Product Change Notice (PCN)

PCN Number: **PCN-0456191R-01**

Product(s) Affected: **PJ-042H**

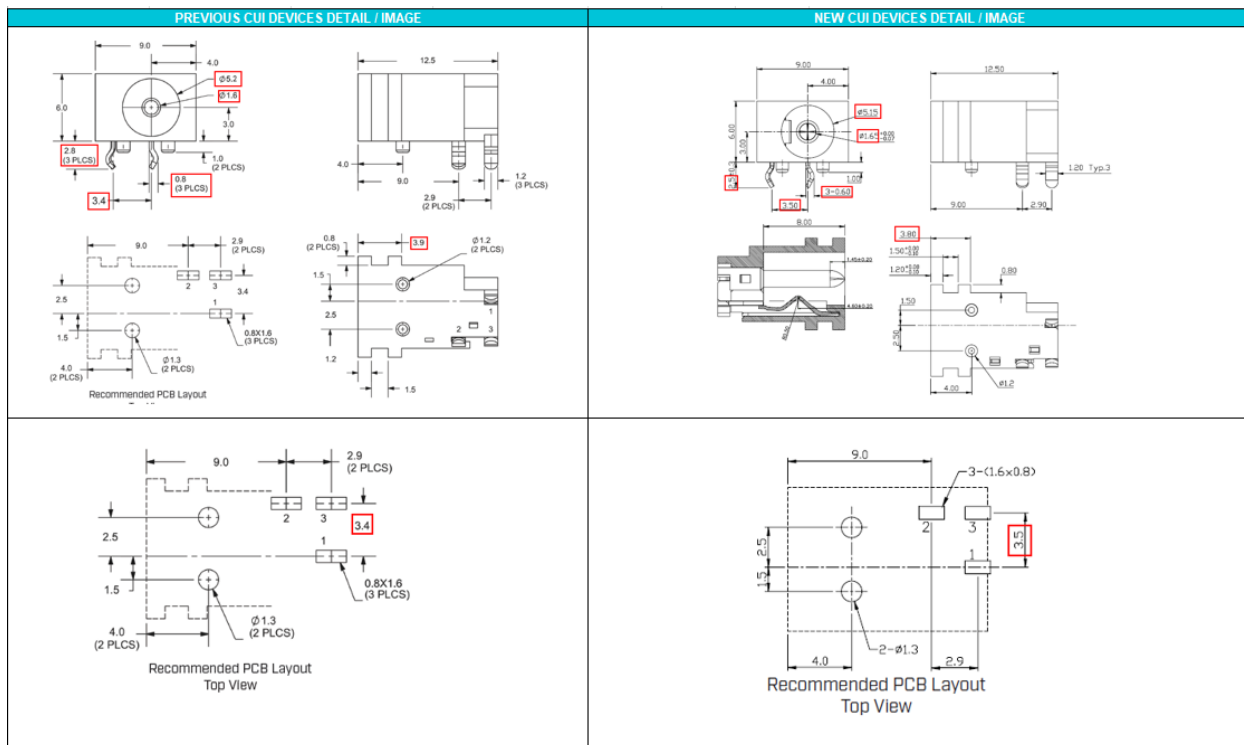
Description of Change: **New Factory Location. Product re-engineered for improved manufacturability and production yield. See image below for reference and check CUI Devices website for updated drawing. Cosmetic differences may be visible and not affect the form fit and function of the product.**

PREVIOUS CUI DEVICES DETAIL / IMAGE			NEW CUI DEVICES DETAIL / IMAGE		
DESCRIPTION	MATERIAL	PLATING/COLOR	DESCRIPTION	MATERIAL	PLATING/COLOR
center pin	brass	tin	center pin	bronze	tin
terminal 1	brass	tin	terminal 1	bronze t=0.35	tin
terminal 2	phosphor bronze t=0.3	tin	terminal 2	B2-Cu t=0.30	tin
terminal 3	brass t=0.3	tin	terminal 3	brass t=0.40	tin
housing	PAB6 (UL94V-0)	black	housing	PAB6-30%GF (UL94V-0)	black
MATING PLUG Jack Insertion Depth: 7.8 mm			MATING PLUG Jack Insertion Depth: 8.0 mm

Affected Date Code: All orders placed before **09/10/2024** will be pre-PCN parts. Orders placed after **09/10/2024** will be manufactured in accordance with the PCN. Please check updated 2D drawing on or after **09/10/2024**.
